REF: SPR-30-24  
DATE: July 11, 2024

Request	-	Major Site Plan Review for a Self-Storage Facility
Location	-	5055 Jackman Road
Applicant / Owner	-	AFS Jackman LLC 1851 Madison Avenue, Suite 300 Council Bluffs, IA 51503

MAJOR SITE PLAN REVIEW  
TOLEDO CITY PLAN COMMISSION  
REF: SPR-30-24  
DATE: July 11, 2024  
TIME: 2:00 P.M.

# SITE PLAN

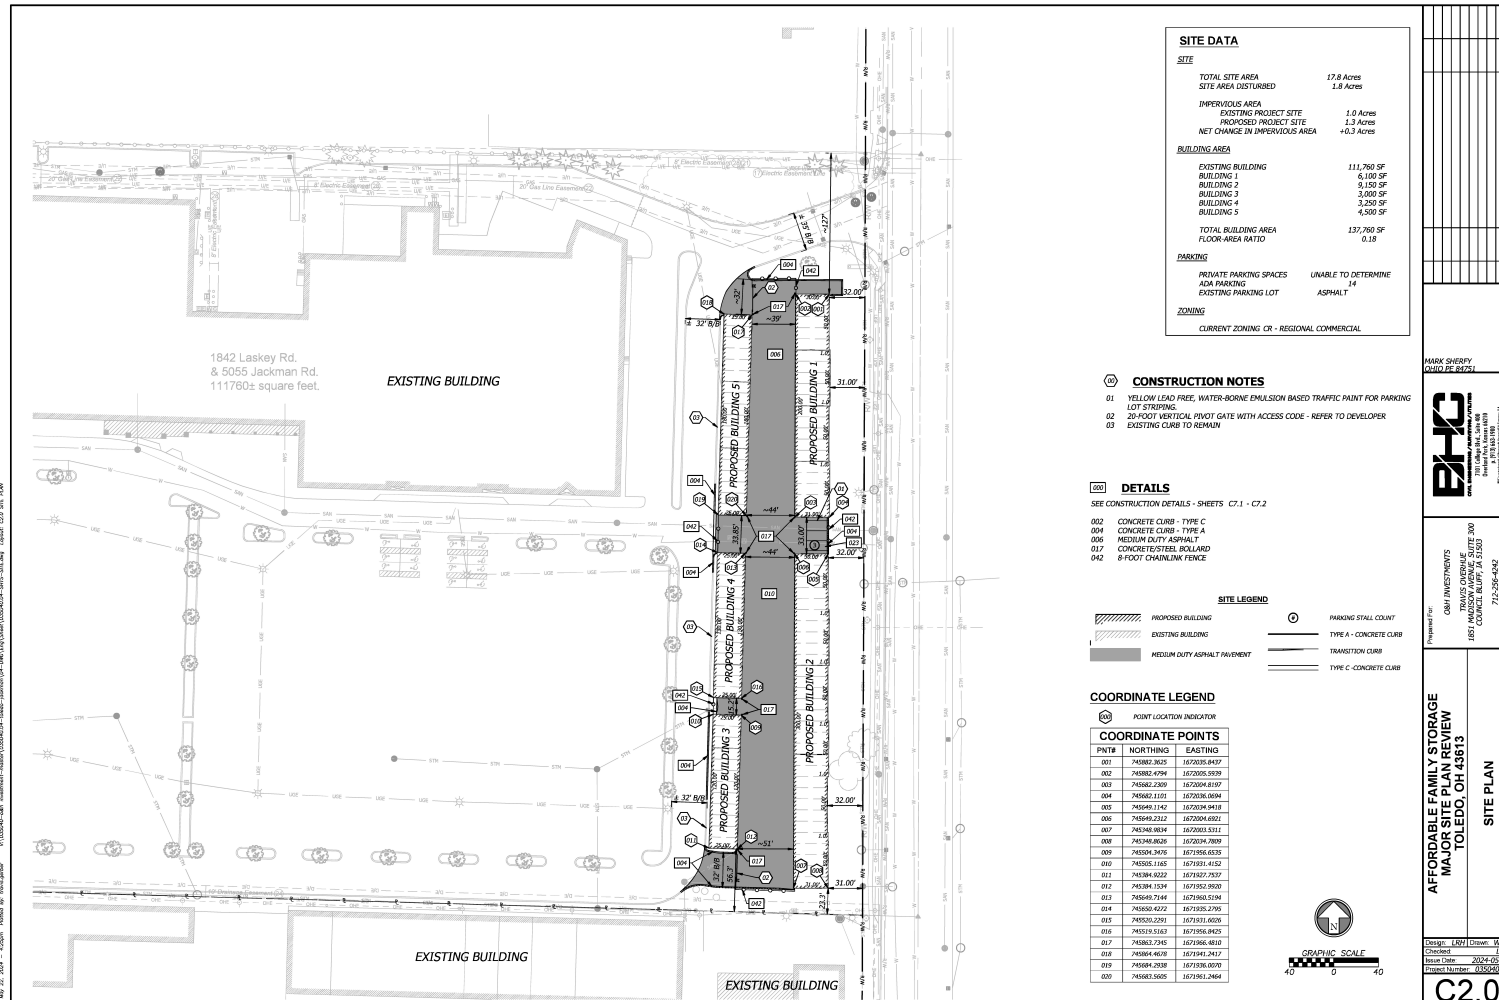
TMC§1107.0300 *Off-street parking Schedule “A”* requires a minimum of five (5) off-street parking spaces for the proposed Self-Storage Facility. The submitted site plan provides three (3) within the site plan boundaries; however, there is a large parking field on the same property to the west. The applicant intends to occupy the adjacent property and parking area along with the proposed Self-Storage Facility. These parking spaces will more than comply with TMC§1107.0300.

Accessible parking spaces must be provided according to TMC§1107.1700 *Accessible Parking for Physically Disabled Persons*. The submitted site plan shows no new accessible parking spaces. The applicant intends to use existing accessible parking spaces in the parking field to the west. Required spaces for persons with disabilities must be located in close proximity to building entrances and be designed to permit occupants of vehicles to reach the building entrance on an unobstructed path. The existing accessible parking spaces are not located withing close proximity to the proposed facility. A revised site plan shall be submitted depicting the required accessible parking spaces and listed as a condition of approval.

A minimum of one (1) bicycle parking space per ten (10) automobile parking spaces is required pursuant to TMC§1107.0300 *Off-Street Parking Schedule “A”*. None are shown on the submitted site plan, however a minimum of two (2) spaces shall be provided on site. A revised site plan shall be submitted depicting the required minimum bicycle parking and listed as a condition of approval.

Pursuant to TMC§1109.0204, at least one (1) main entrance of the facility shall face and open directly onto a five-foot (5') wide connecting walkway to the street sidewalk without requiring pedestrians to walk around buildings or around parking lot outlines which are not aligned to a logical route. Connecting walkways may cross parking aisles or driveways if distinguished from driving surfaces through the use of durable, low maintenance surface materials such as pavers, bricks, scored concrete or scored and painted asphalt to enhance pedestrian safety and comfort. Raised walkways may be installed if elevated six inches (6") with tapered side slopes and meet ADA standards. A revised site plan shall be submitted showing compliance with this section and listed as a condition of approval.

27. Off-street parking shall be provided pursuant to Off-Street Parking Schedule "A," (TMC§1107.0304). A total of five (5) parking spaces are required for this site. The submitted site plan shows three (3) parking spaces. **Not acceptable as depicted. Revised site plan must show additional parking on the existing parking field to the west.**

28. Bicycle parking slots shall be provided pursuant to Off-Street Parking Schedule "A," (TMC§1107.0300). Minimum number of bicycle parking slots required for mini-storage is one (1) bicycle parking per ten (10) parking spaces. **Not acceptable as depicted. Revised plan shall be submitted depicting the required minimum bicycle parking.**

29. Any spaces reserved for the use by persons with physical disabilities shall adhere to the standards outlined in TMC§1107.1700. One (1) van accessible space is required. Accessible spaces shall be located within close proximity to the building and shall be designed to permit occupants to reach the building entrance on an unobstructed path. **Not acceptable as depicted. Revised plan shall be submitted depicting the required accessible parking spaces.**

32. At least one main entrance of the facility shall face and open directly onto a 5 foot wide connecting walkway to the street sidewalk without requiring pedestrians to walk around buildings or around parking lot outlines which are not aligned to a logical route. **Not acceptable as depicted. A revised site plan shall be submitted showing compliance with TMC§1109.0204.**

LANDSCAPE PLAN

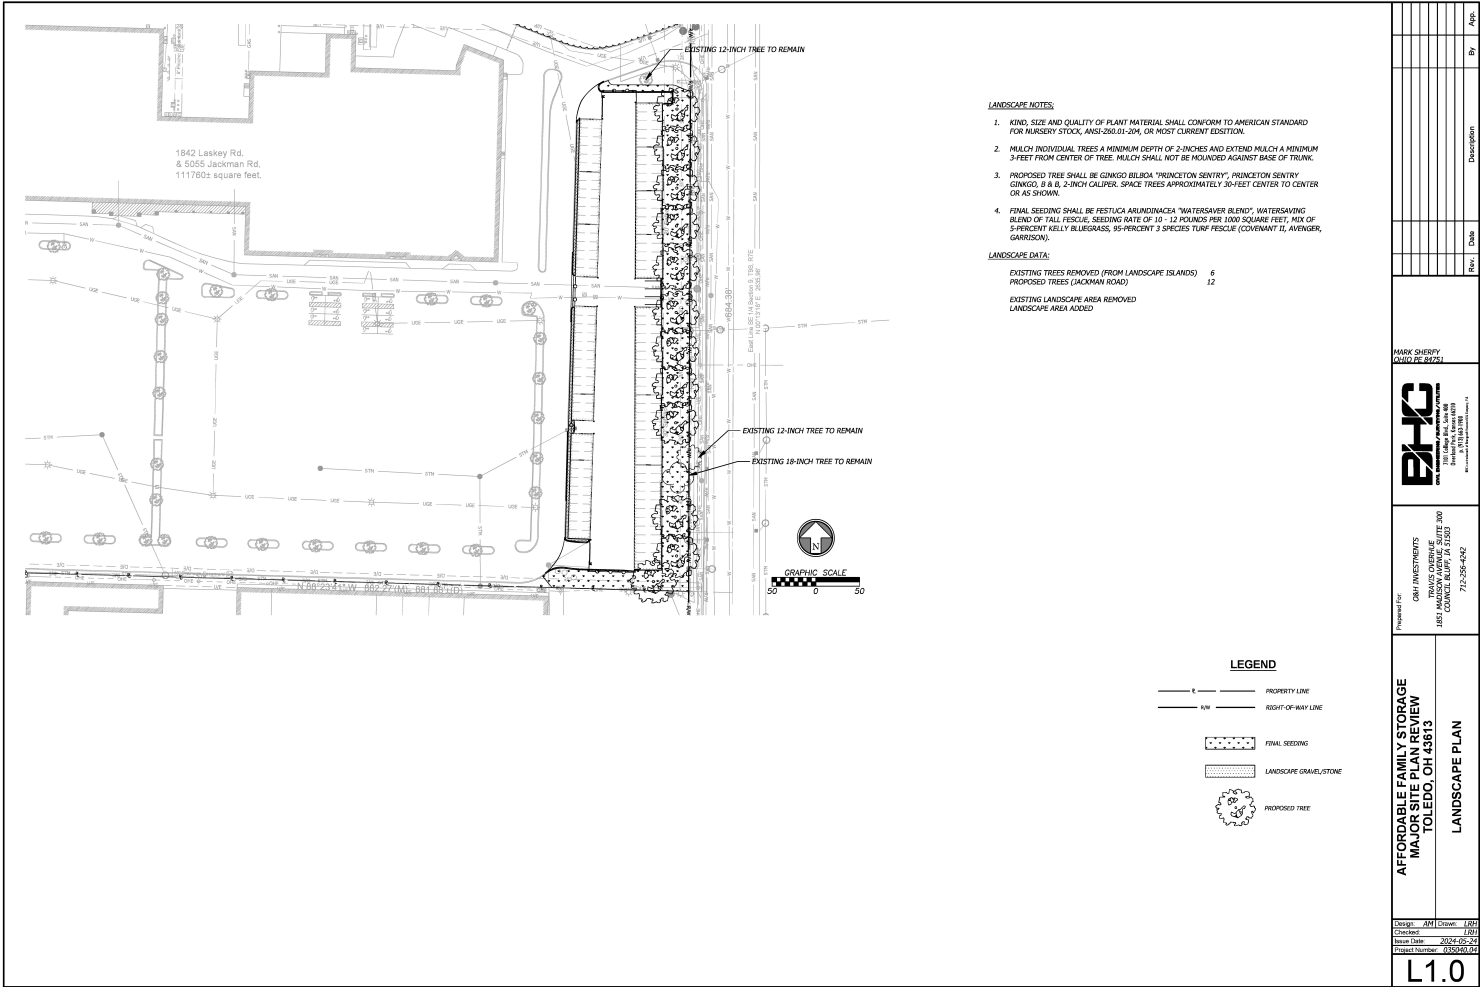
Pursuant to TMC§1108.0202 *Frontage Greenbelt*, a thirty-foot (30') frontage greenbelt is required along Jackman Road. At least twenty-three (23) trees are required within the frontage greenbelt. The submitted landscaping plan shows fifteen (15) trees – three (3) of which are existing. TMC§1108.0407 *Tree Preservation and Credit For Existing Landscape Materials* permits the applicant to use these preserved trees as landscape material credits. Based upon their caliper shown on the submitted landscaping plan, these three (3) trees equate to fourteen (14) tree credits. Trees shown on the submitted landscaping plan comply with TMC§1108.0202 *Frontage Greenbelt*; however, a solid evergreen hedge is required along the parking area fronting on Jackman Road. A low decorative stone or brick wall would also be acceptable to meet this requirement. A revised landscaping plan shall be submitted depicting the required evergreen hedge, or wall, along the parking area facing Jackman Road and listed as a condition of approval.

Pursuant to TMC§1108.0204, a perimeter landscape buffer ten feet (10') in width is required along the southern end of the facility's internal drive aisle. Such perimeter landscape buffer shall include at least one (1) canopy tree and a continuous shrub with a minimum height of eighteen inches (18"). A decorative stone or brick wall will also be acceptable to meet this requirement. A revised landscaping plan shall be submitted depicting the perimeter landscaping and listed as a condition of approval.

In addition to the other landscape requirements for buffer areas and frontage greenbelts, one (1) tree is required for every 1,000 square feet of building coverage and two (2) canopy trees and six (6) shrubs are required for each ten (10) parking spaces. The proposed buildings combined total twenty-six thousand (26,000) square feet and a minimum of five (5) parking spaces are required for the facility. Twenty-eight (28) trees and six (6) shrubs are required. The submitted landscaping plan does not depict any of these required plantings. A revised landscaping plan shall be submitted depicting the interior site landscaping and listed as a condition of approval.

Foundation plantings are required along all portions of the building that are visible from the public rights-of-way. Foundation plantings shall be provided along visible elevations to the north and south of buildings one, two, three, and five. A revised landscaping plan shall be submitted depicting foundation plantings and listed as a condition of approval.

- b. If a parking lot is proposed to be developed in the front of the property, the frontage greenbelt shall include a solid evergreen hedge planting to screen the parking lot so that no headlights of any vehicles can be seen from the public street. **Not acceptable as depicted. Hedge or low brick or stone wall is required along parking area fronting Jackson Street. Revised landscaping plan shall be submitted depicting the required evergreen hedge, or wall, along the parking area facing Jackman Road.**

- c. A perimeter landscape buffer ten feet (10') in width is required along the southern end of the facility's internal drive aisle. Such perimeter landscape buffer shall include at least one (1) canopy tree and a continuous shrub with a minimum height of eighteen inches (18"). **Not acceptable as depicted. One (1) canopy tree and a continuous shrub is required. Low brick or stone wall may be used as a substitute for continuous shrub. Revised landscaping plan shall be submitted depicting the required perimeter landscaping.**

- d. Two (2) canopy trees and six (6) shrubs are required to be installed in interior landscape areas for each ten (10) parking spaces within the parking lot. Two (2) trees and six (6) shrubs are required for this site. **Not acceptable as depicted. Two (2) additional trees and six (6) additional shrubs are required. Revised landscaping plan shall be submitted depicting the required plantings.**

- e. One 2-inch caliper tree for every 1,000 square feet of building coverage shall be required. Twenty-six (26) trees are required for this site. As long as the required buffer areas are sufficiently screened, the additionally required trees may be placed anywhere on the parcel. **Not acceptable as depicted. Approval of final landscape plan will be upon the discretion of the Planning Director.**

- f. Foundation plantings shall be required along the portions of the building visible from the right-of-way. **Not acceptable as depicted. Foundation plantings shall be provided along visible northern and southern façades and shown on a revised landscaping plan.**
